CITY OF ALBUQUERQUE

**RE: Albuquerque Central Care Center
621 Columbia Dr. SE
Grading and Drainage Plan
Engineer's Stamp Date: 10/09/19
Hydrology File: L16D042**

Based upon the information provided in your submittal received 11/13/2019, the Grading & Drainage Plan **is not** approved for Building Permit. The following comments need to be addressed for approval of the above referenced project:

C-2

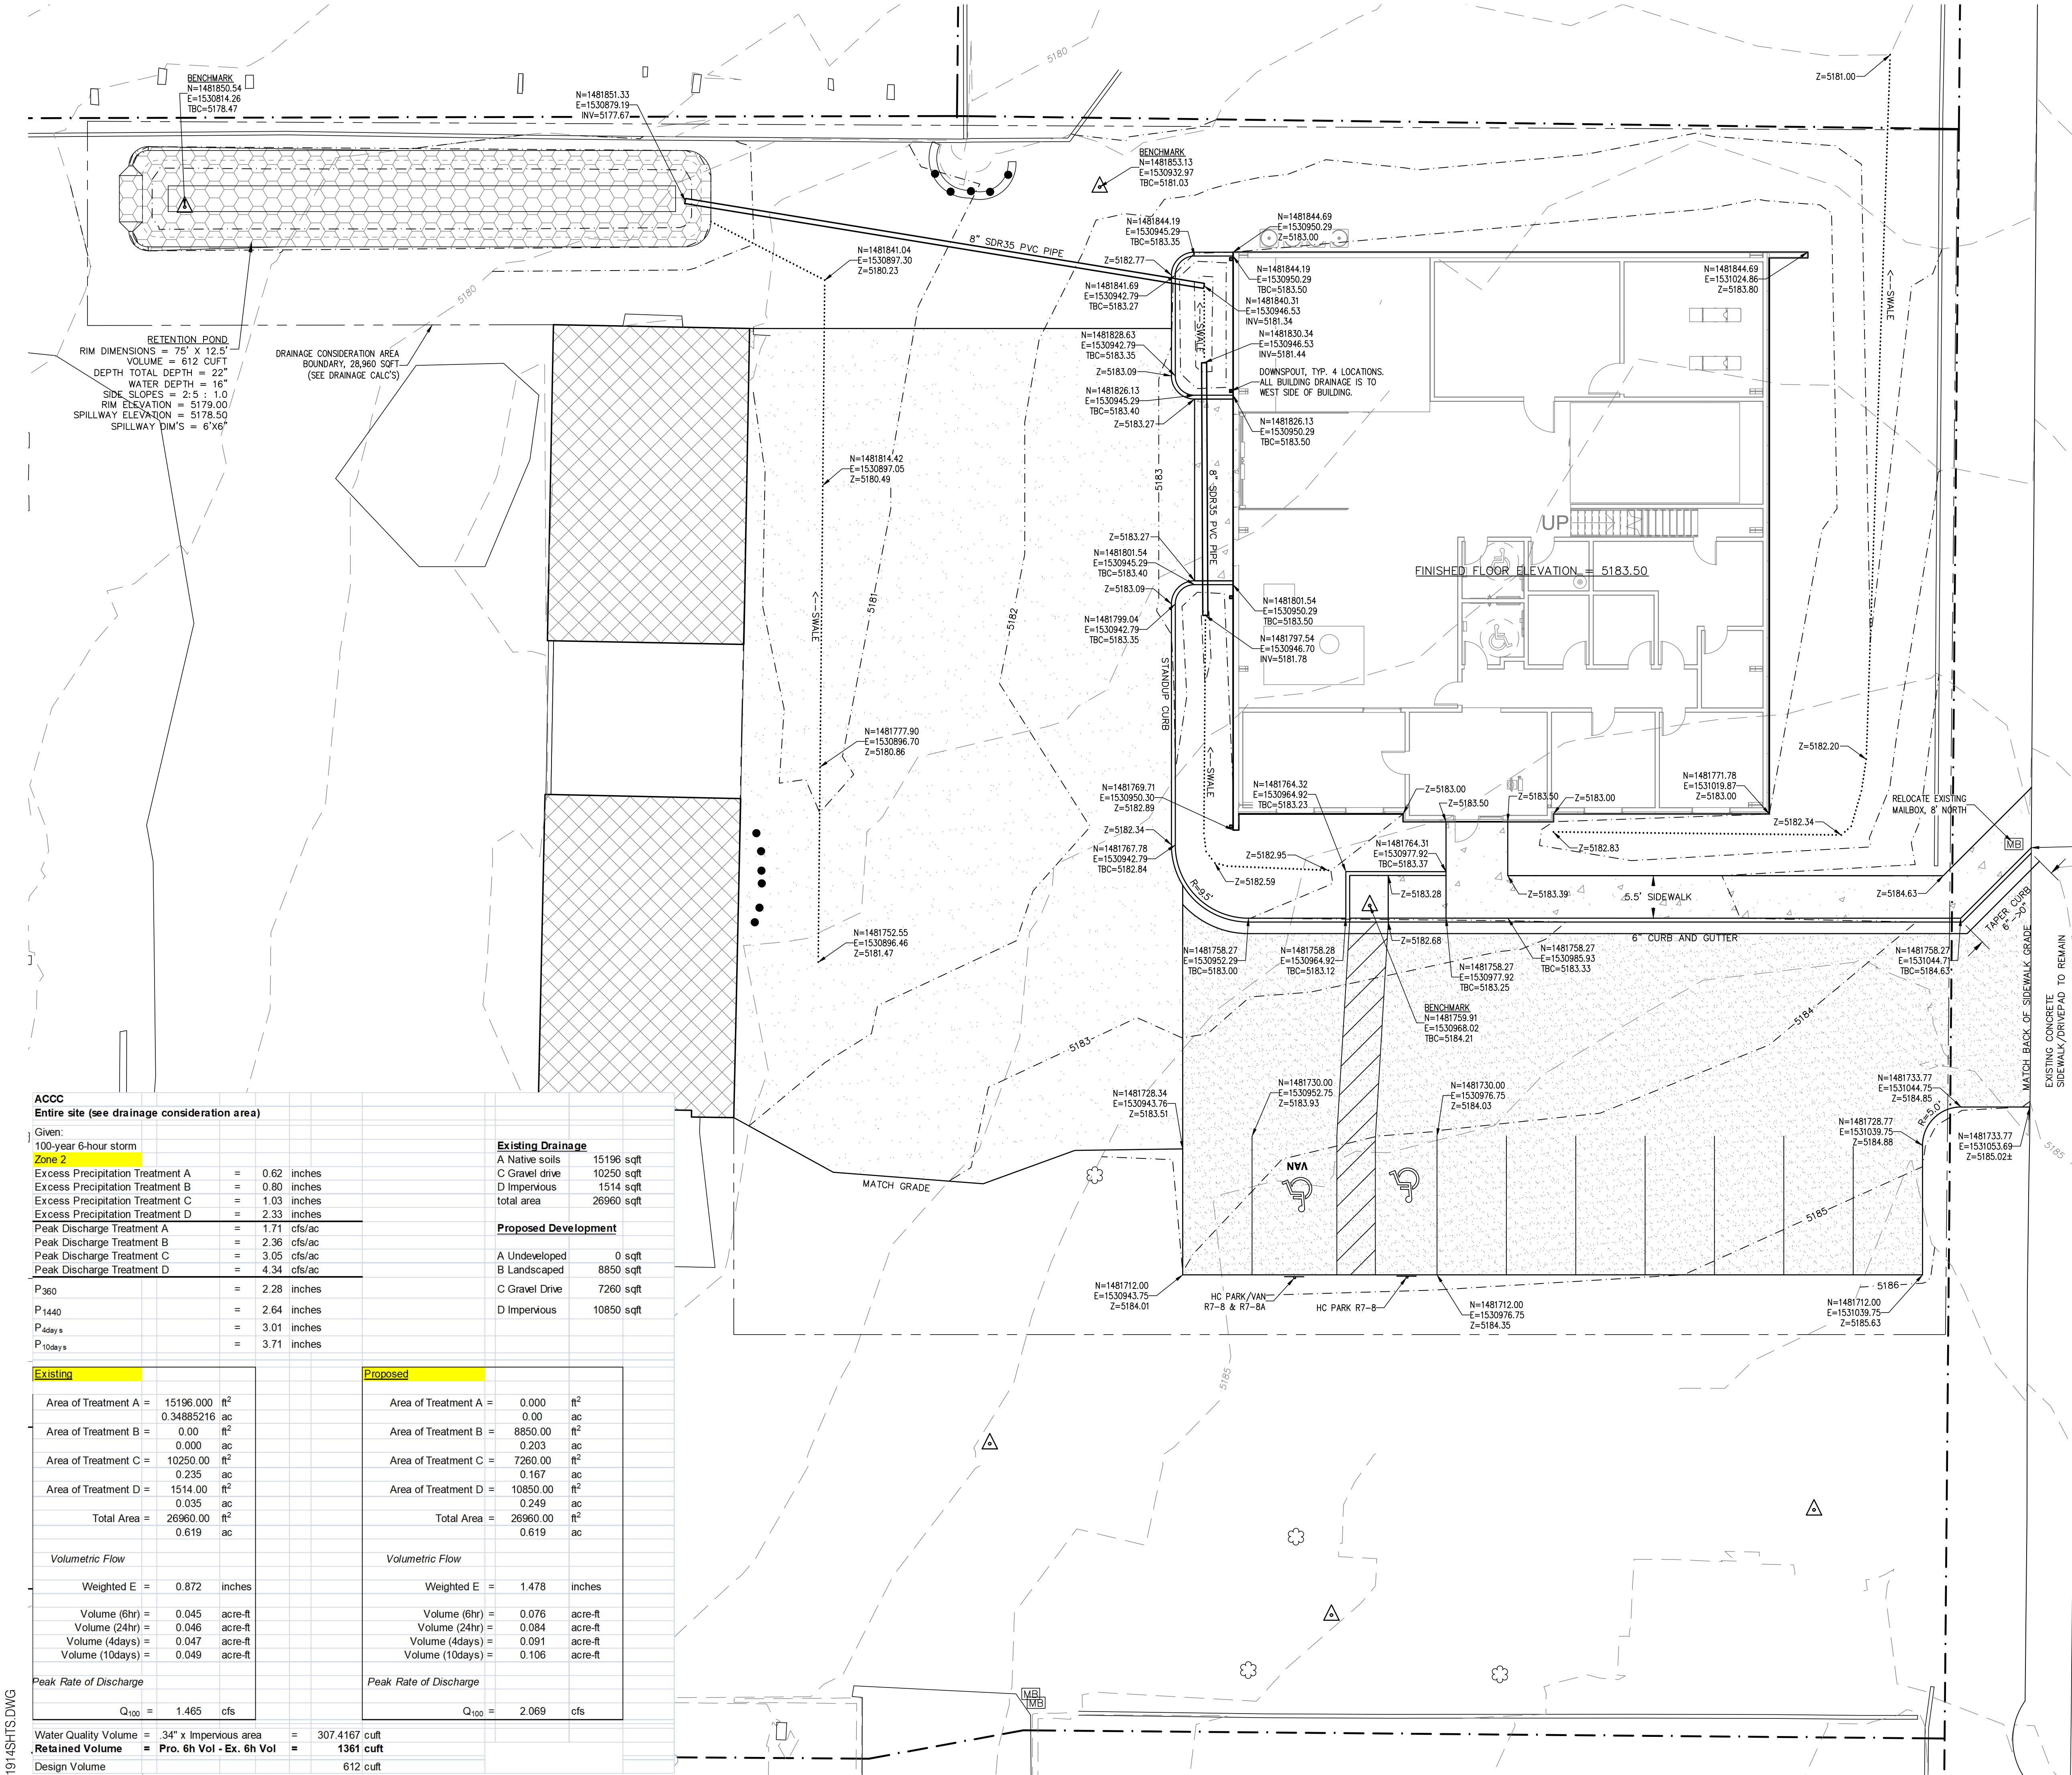
1. Per the DPM Chapter 22 Section 7 - Grading Plan Checklist, the following must be on the Grading Plan. Please correct any deficiencies with the Grading Plan.

- a. Please provide an engineer's stamp with a signature and date.
 - b. Please use 1" = 20' for the scale.
 - c. Please provide a Vicinity Map.
 - d. Please provide the Benchmark information (location, description and elevation) for the survey contour information provided.

- e. Please provide the FIRM Map and flood plain note with effective date.
 - f. Please provide a legal Description of the property.
2. Please provide the required water block per COA Paving Detail No. 2426 at the driveway. This is to ensure that the drainage from Columbia Dr. does not enter the site.

3. Is this property to be platted? If so, then please show the preliminary property line. Also when you resubmit, please also ask for an approval for Preliminary Plat.

4. In the drainage calculations, please use the proposed acreage of the Preliminary Plat as the total area in all the calculations. Also for the Existing Drainage calculations, there will be no Type A (native soil) in this area. This site is comprised of either

landscape area (Type B), graded earth or gravel (Type C), and impervious (Type D). Please correct the calculations.

5. Please change the pond from “Retention Pond” to “Stormwater Quality Pond”. This is the terminology that was changed in the latest Drainage Ordinance.
6. Standard review fee of \$150 will be required at the time of resubmittal.
